DATE: AUGUST 24, 2012

SUBJECT: BIDDER QUESTION RESPONSES

PROJECT: **RELOCATE JOLIET CBOC PHASE I - BID PACKAGE B**

2 BASEMENT ENLARGED EQUIPMENT PLAN
SCALE: 1/4"=1'-0"

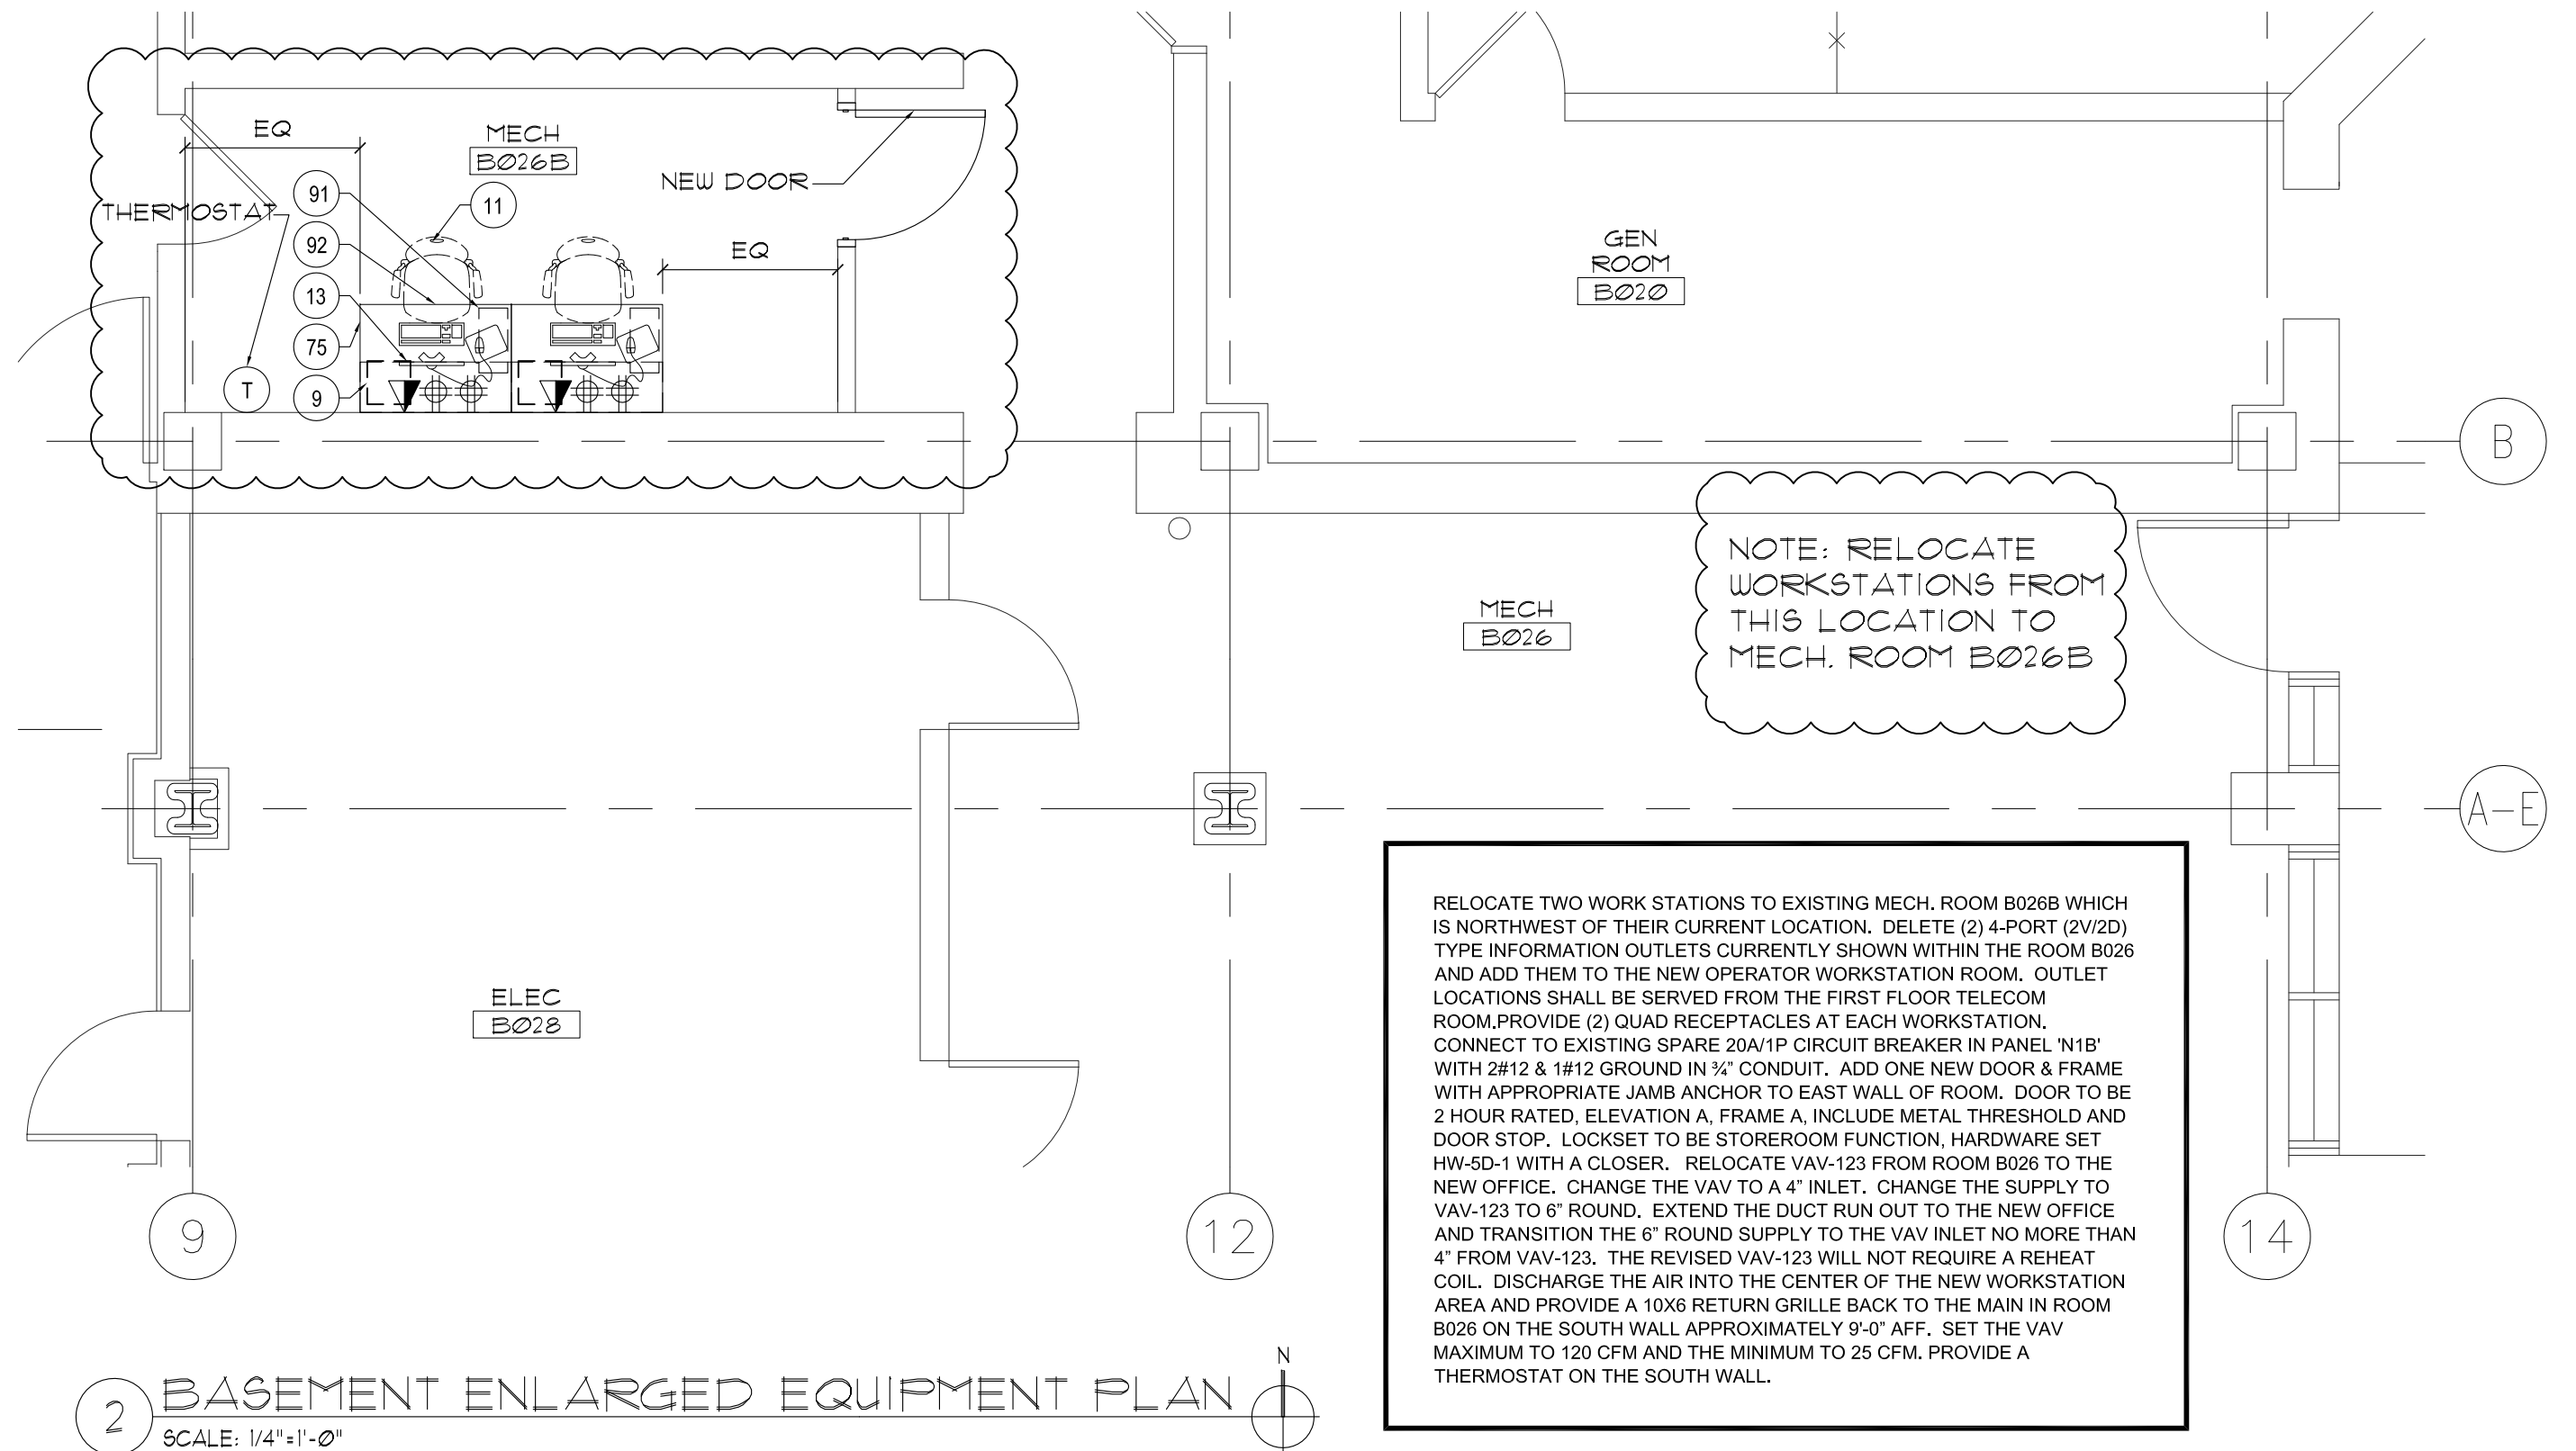
101. Is the location of the two workstation in the south mechanical room correct.

Answer: These two work stations are to be relocated to existing mech. room B026B which is northwest of their current location. Delete (2) 4-port (2V/2D) type information outlets currently shown within the room B026 and ADD them to the new operator workstation room. Outlet locations shall be served from the first floor telecom room. Provide (2) quad receptacles at each workstation. Connect to existing spare 20A/1P circuit breaker in Panel 'N1B' with 2#12 & 1#12 ground in ¾" conduit. Add one new door & frame with appropriate jamb anchor to East wall of room. Door to be 2 hour rated, elevation A, Frame A, include metal threshold and door stop. Lockset to be storeroom function, hardware set HW-5D-1 with a closer. Relocate VAV-123 from room B026 to the new office. Change the VAV to a 4" inlet. Change the supply to VAV-123 to 6" round. Extend the duct run out to the new office and transition the 6" round supply to the VAV inlet no more than 4" from VAV-123. The revised VAV-123 will not require a reheat coil. Discharge the air into the center of the new workstation area and provide a 10x6 return grille back to the main in room B026 on the south wall approximately 9'-0" AFF. Set the VAV maximum to 120 CFM and the minimum to 25 CFM. Provide a thermostat on the South Wall. Refer to attached sketch BPB-ASK-1.

SUPP. DWG - 1

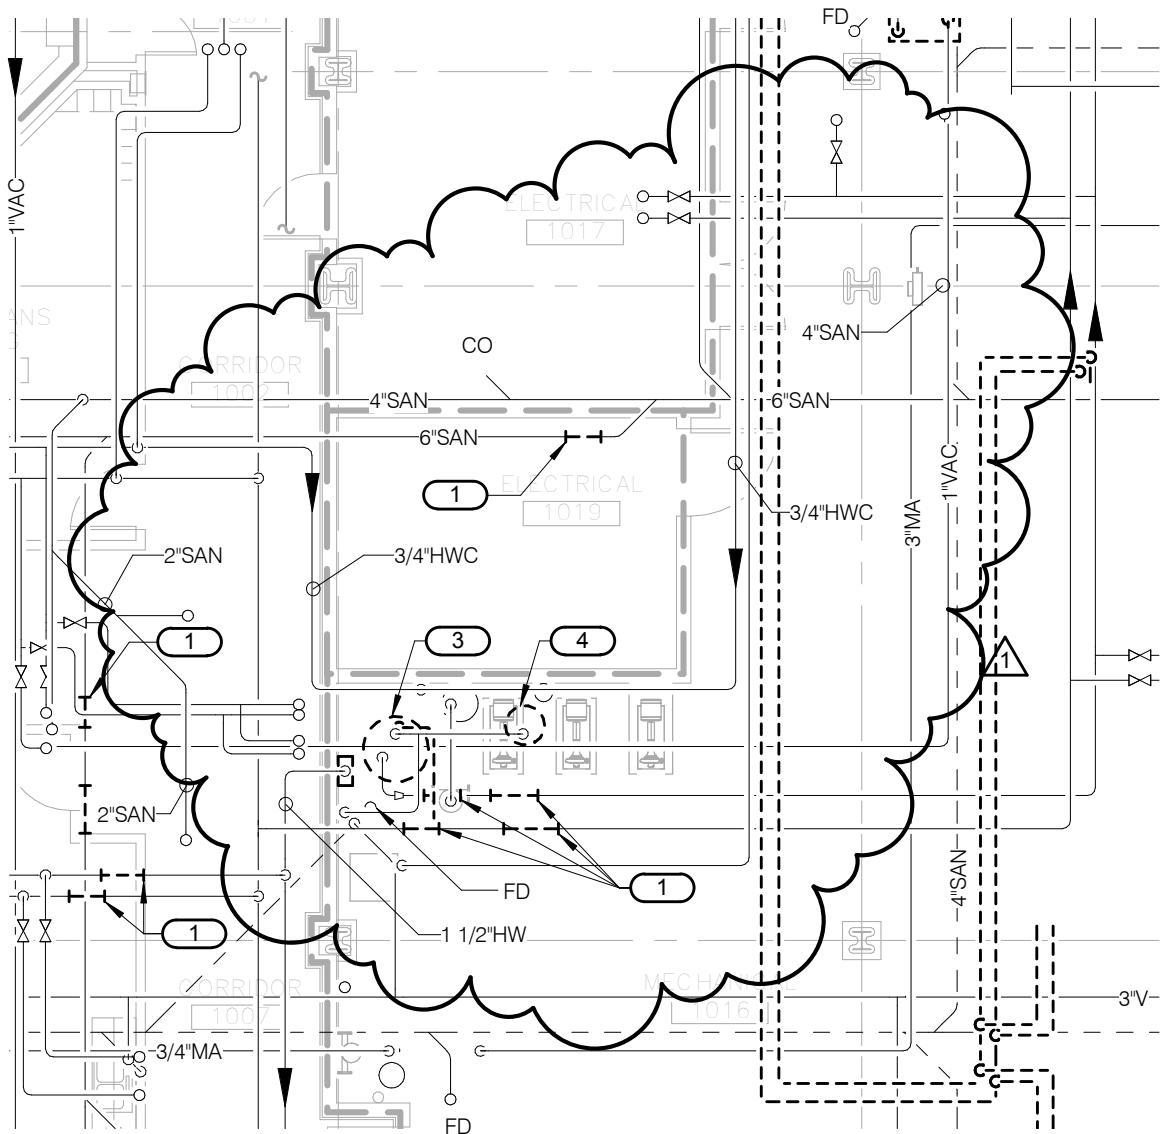
74. Clarification needed in keynotes on sheet PL-110A.

Answer: REVISE Keynote 2 to read as follows: "Extend 2" HW and 1" HWC and connect to existing HW and HWC lines at demolished water heater. Disconnect existing water heater, mixing valve, and recirculating pump. See PD-110A for demolition." Refer to attached supplemental drawing #1.

REVISE Keynote 3 to read as follows: "Reconnect existing CW lines serving demolished water softener in this area. See PD-110A for water softener removal." Refer to attached supplemental drawing #1.

1 SUPP. DWG - 2

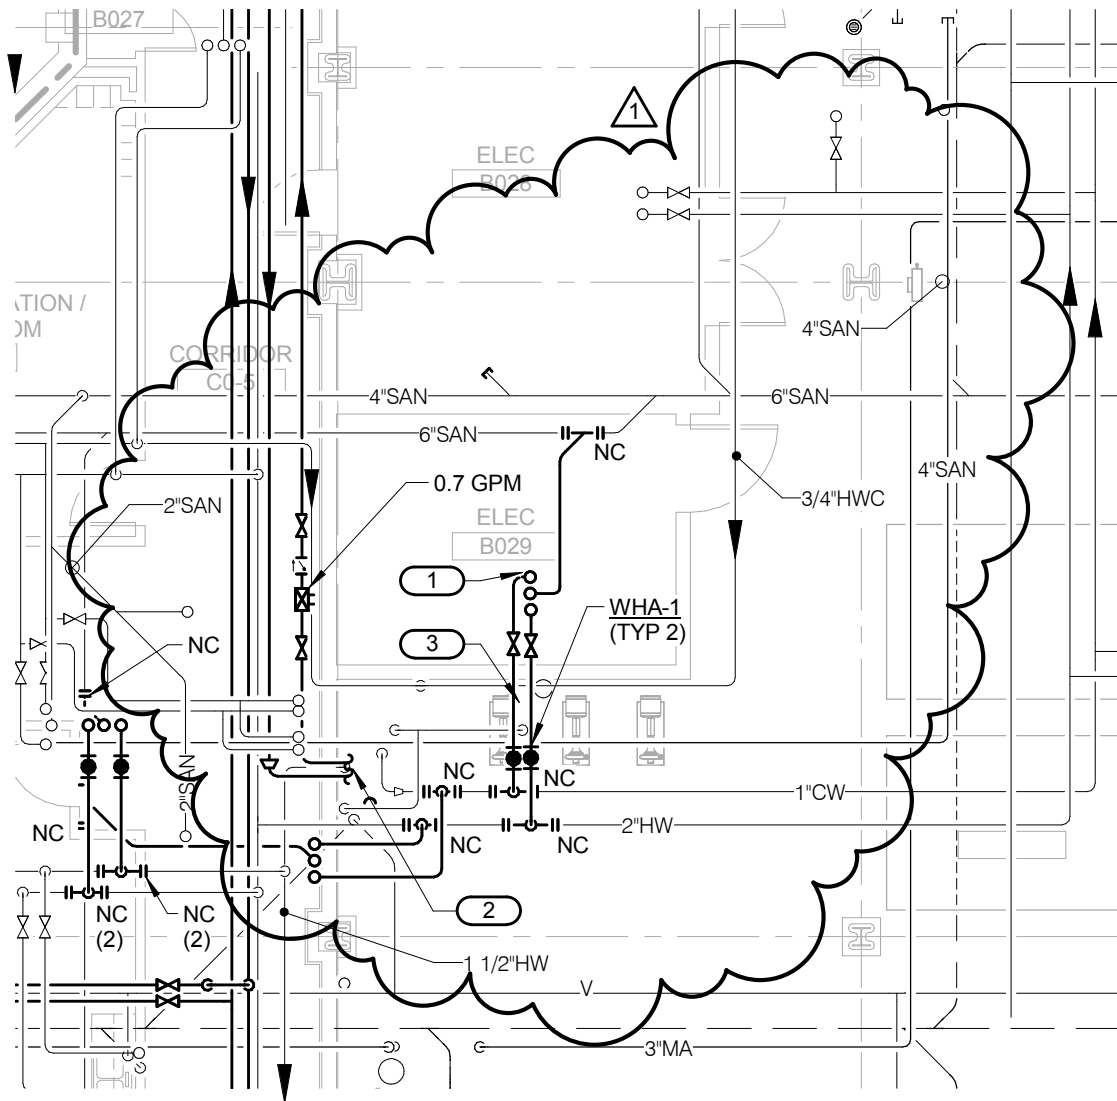
71. Clarification needed in keynotes on sheet PD-110A.

Answer: REVISE Keynote 3 to read as follows: "Remove existing water heater, mixing valve, circulation pump, and associated piping as required. HW and HWC lines to be reconnected to new HW and HWC. Refer to PL-110A for reconnection." Refer to attached Supplemental drawing #2.

REVISE Keynote 4 to read as follows: "Remove existing water softener and associated piping as required. CW lines to be reconnected together. Refer to PL-110A for reconnection." Refer to attached supplemental drawing #2.
